# FMB110 Product Change Notifications

[Main Page](#) > [Advanced Trackers](#) > [FMB110](#) > **FMB110 Product Change Notifications**

## 2021.01.01: Top Laser Printing Changes

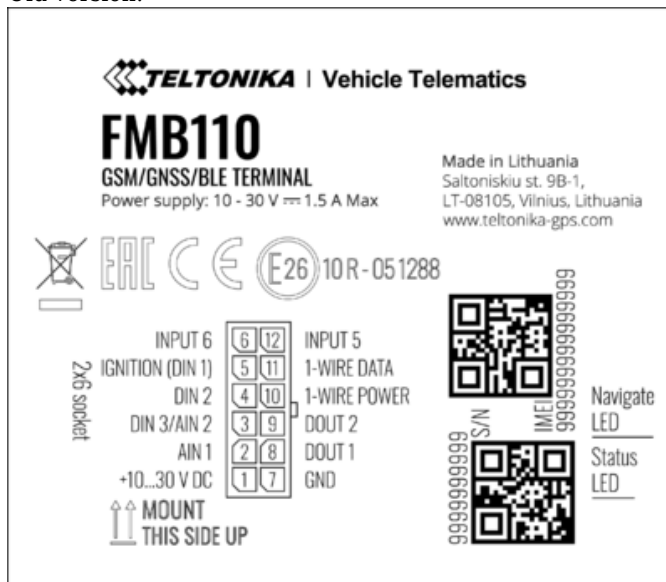
Change type	External/visual
	Top laser printing design changed
	Old version:

Change reasons	1. Updated Emark certificate number. 2. Added UKCA label. 3. Updated Teltonika brand to Teltonika Telematics.
Product release date	January 2021
